**RE: Construction Permit Application for a Proposed Utility Waste Landfill, Ameren Missouri
Labadie Energy Center, Franklin County, Missouri, Response to Comment Letter dated May 7,
2013**

Construction Permit Application
Proposed Utility Waste Landfill
Ameren Missouri Labadie Energy Center
Franklin County Missouri

Response to MDNR-SWMP Review Comments

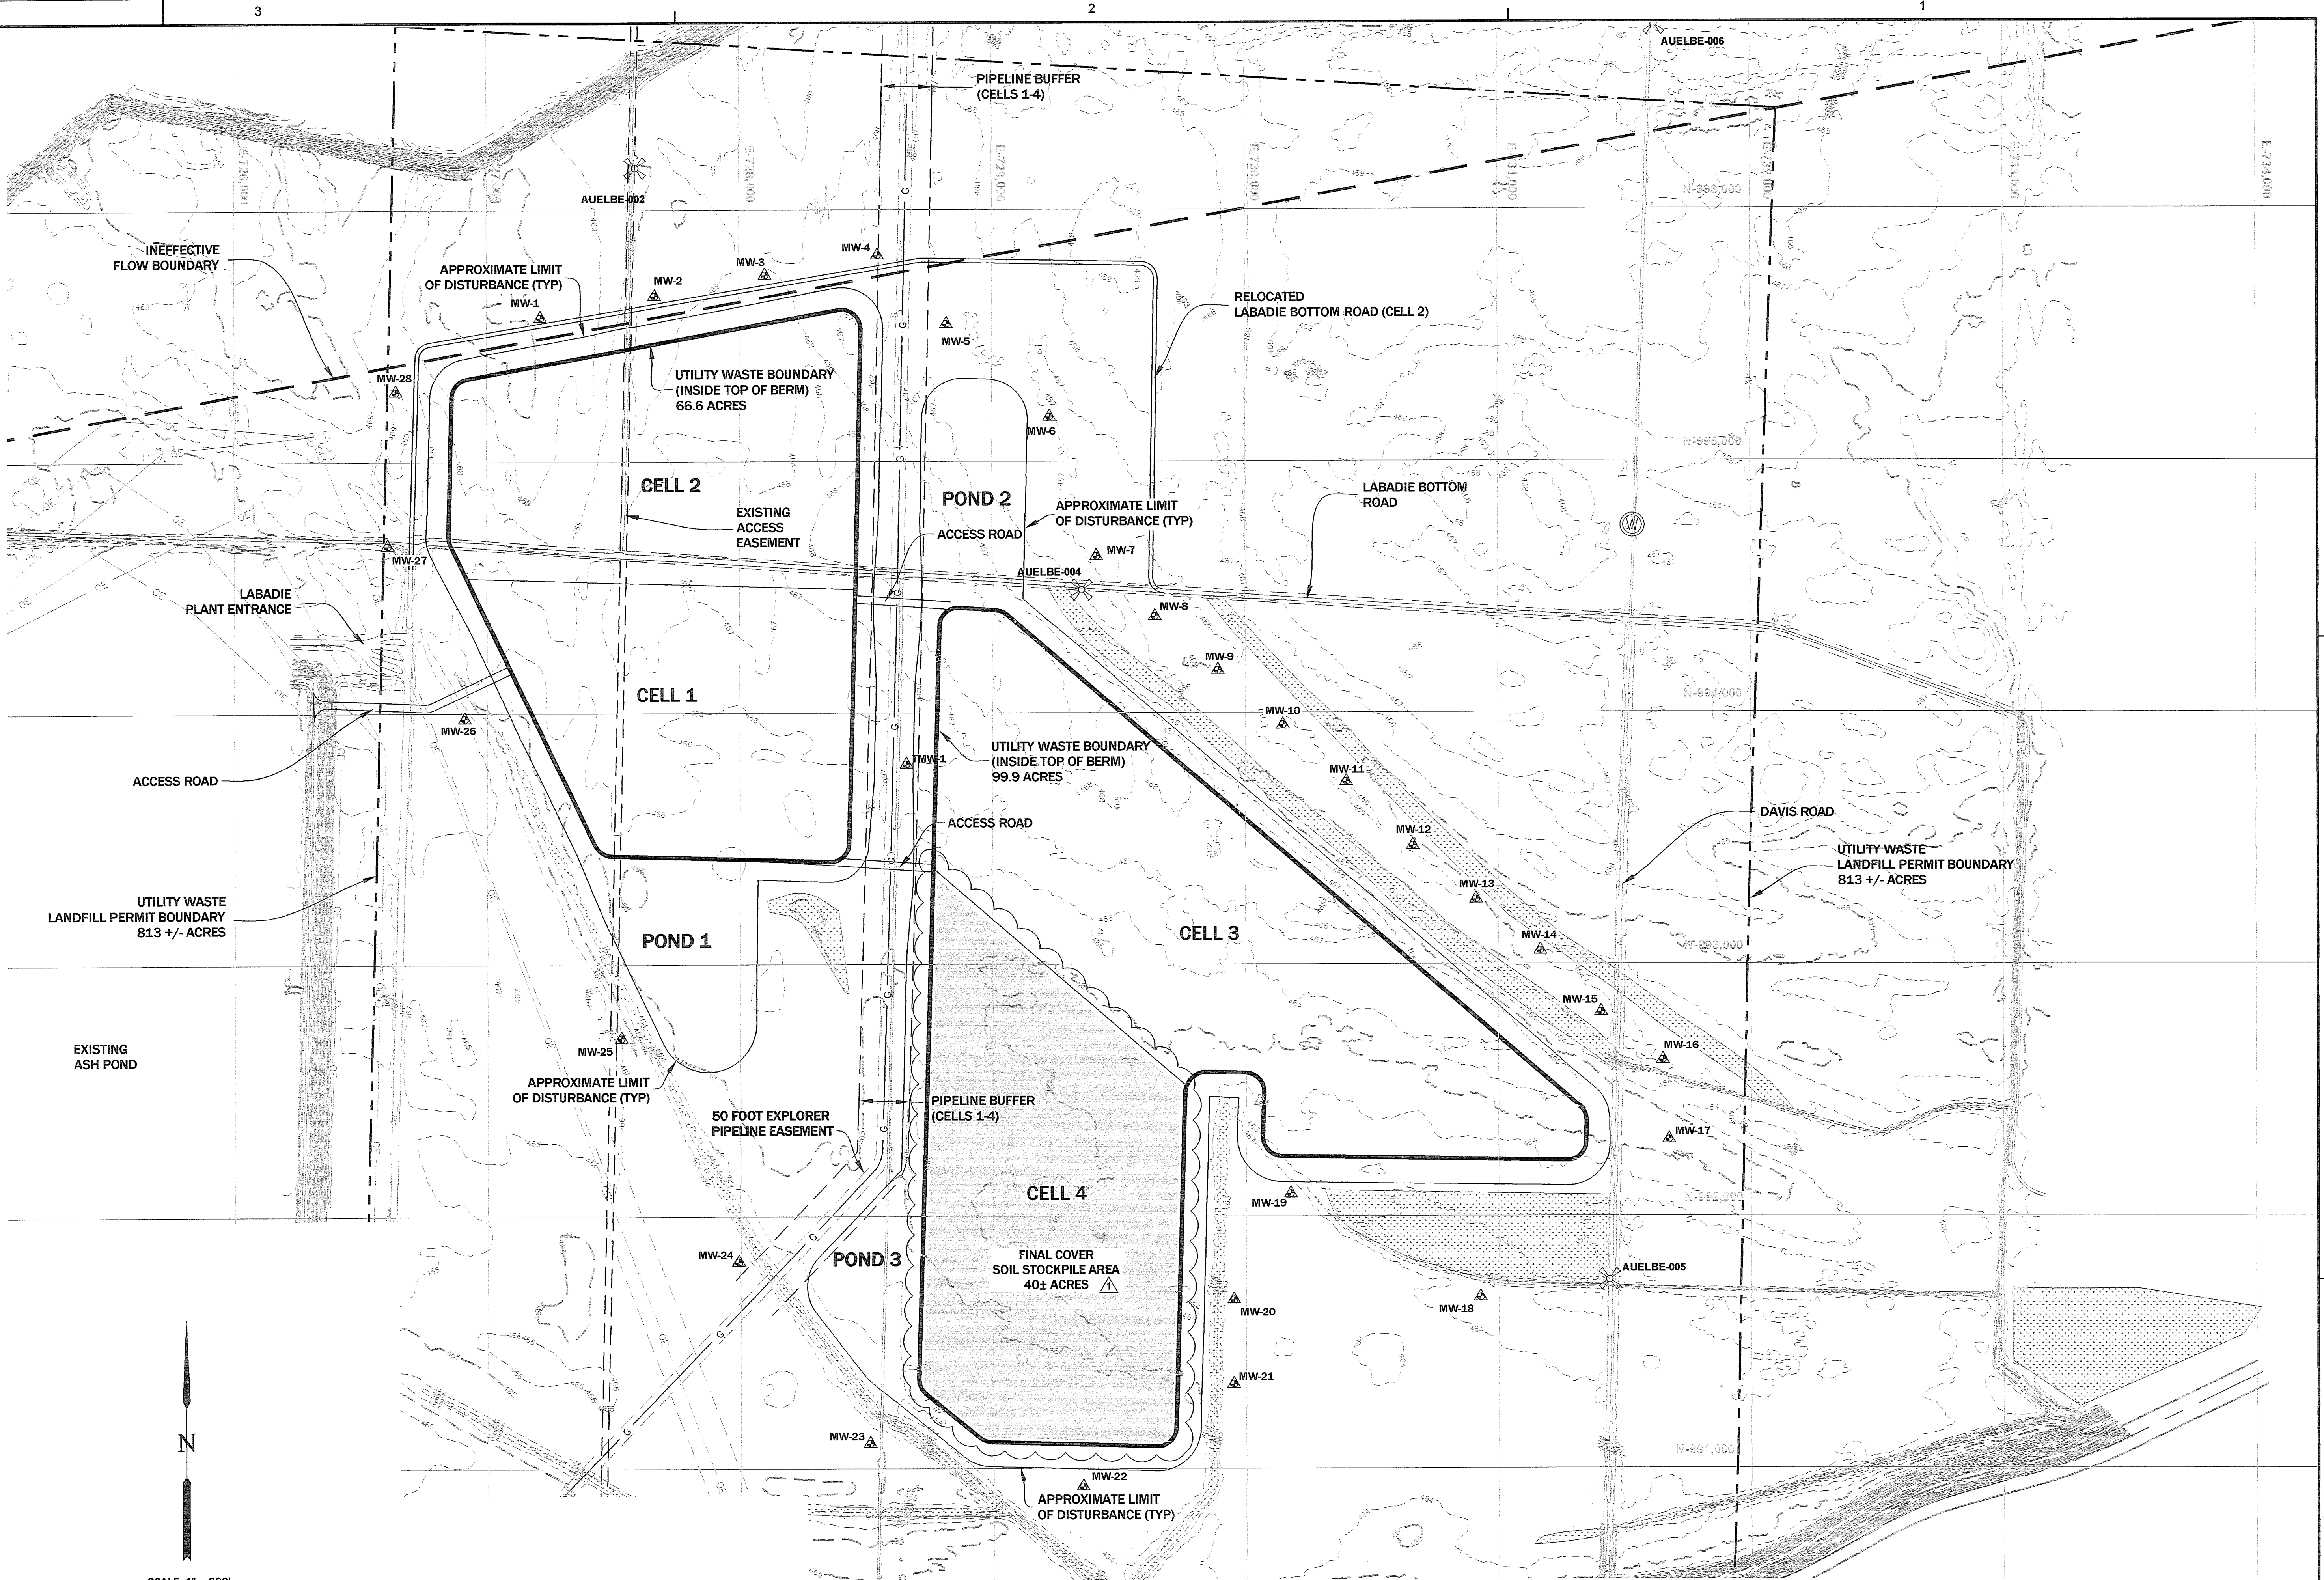
MDNR 6 Per 10 CSR 80-11.010(4)(B)2.A., please show the setbacks to wetland areas and other buffers on Sheet 3. **Response:** Sheets 3, 5, 10 and 19 have been revised to identify a minimum 25 foot buffer between the limits of disturbance and jurisdictional wetland areas. A note has also been added to Sheet 3 regarding the limited activities allowed north of the Ineffective Flow Boundary (i.e. no fill may be placed north of the Ineffective Flow Boundary).

MDNR 16 Per 10 CSR 80-11.010(4)(B)5.D., please indicate location and quantity of closure cover material dedicated to the Department, and depict this area on Sheet 3 of the plans. **Response:** Final cover needs are calculated in Appendix K to be 591,000 cubic yards of soil. Sheet 3 shows the outside toe of the exterior berms (the approximate limits of disturbance) to be 225 acres (Appendix K). During construction of the landfill, we previously indicated that 1.5 feet of soil suitable for final cover would be excavated from within the berm limits to establish

the base construction grade. With 5% swell, the total soil volume generated during this site preparation was approximately 572,000 cubic yards, leaving a deficit of 19,000 cubic yards. By increasing the depth of initial soil stripping to 1.75 feet, sufficient soil will be removed to provide all final cover. As a cell is developed, a minimum of 1.75 feet of soil will be stripped on average from the cell and stockpiled within the landfill footprint outside all jurisdictional areas and will be dedicated to the Department for final cover. Therefore the area shown on Sheet 3 as the outside toe of berm is the limit and location of the soil that is dedicated to MDNR for final cover. Appendix K and Sections 1.2, 2.9.1, 3.2.2, 3.3.4, 3.12.1, 3.12.1.1, and 4.9 of the engineering report have been revised to reflect these provisions for dedicated final cover soil. The location of the final cover stockpile in Cell 4 has been added to Sheet 3 of the plans.

1. NO FILL MAY BE PLACED NORTH OF THE INEFFECTIVE FLOW BOUNDARY.
2. ALL LAND DISTURBANCE ACTIVITIES WILL HAVE A 25' MINIMUM SETBACK FROM JURISDICTIONAL WETLANDS WITH A STORMWATER BMP INSTALLED BETWEEN THE DISTURBANCE AND THE WETLAND DURING CONSTRUCTION. SEE DETAIL 4 ON SHEET 19.

SHEET 4
PROPOSED UTILITY WASTE LANDFILL
LAND USE AND ZONING WITHIN ONE
QUARTER MILE

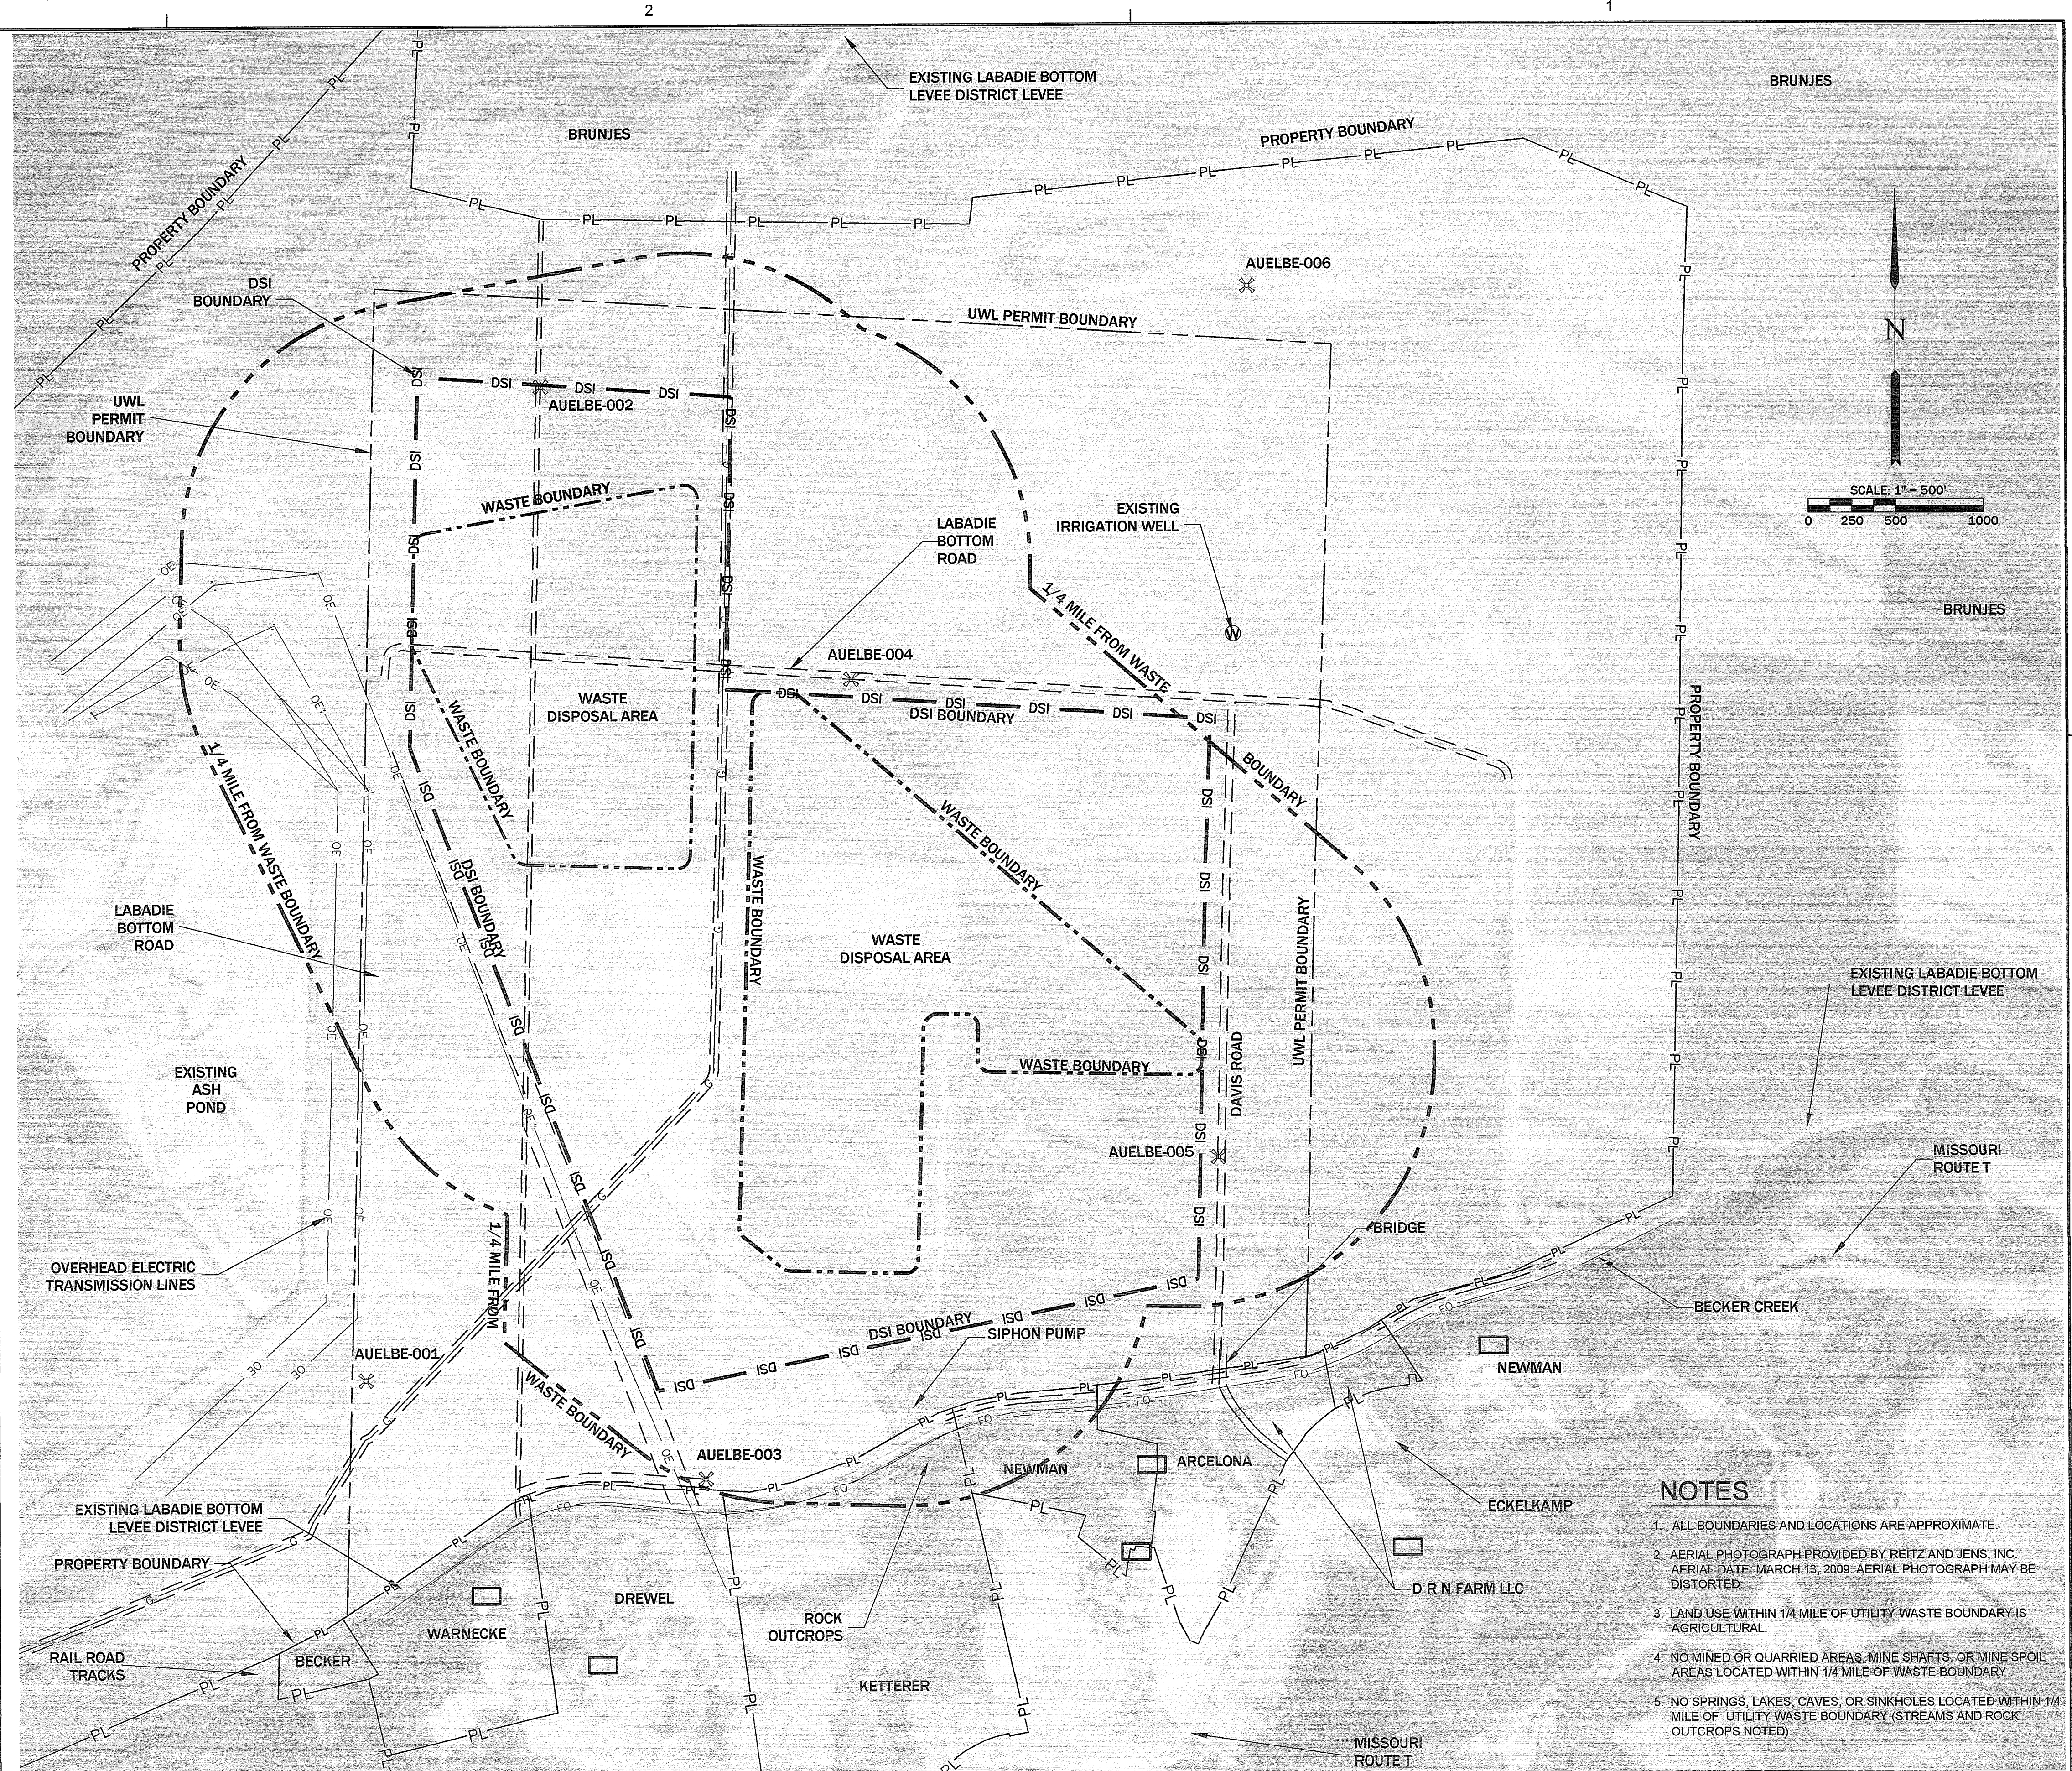
MDNR 7 Per 10 CSR 80-11.010(8)(B)1.F., please show the location of all National Pollution Discharge Elimination System (NPDES) outfalls where this new facility will drain to on Sheet 4. **Response:** Leachate and stormwater that cannot be utilized within the UWL limits for dust control or for conditioning of the ash prior to disposal in the UWL will be pumped back to ash ponds at the plant for discharge through NPDES Outfall 002. The plant map showing the location of Outfall 002 has been added to the lower left-hand corner of Sheet 4.
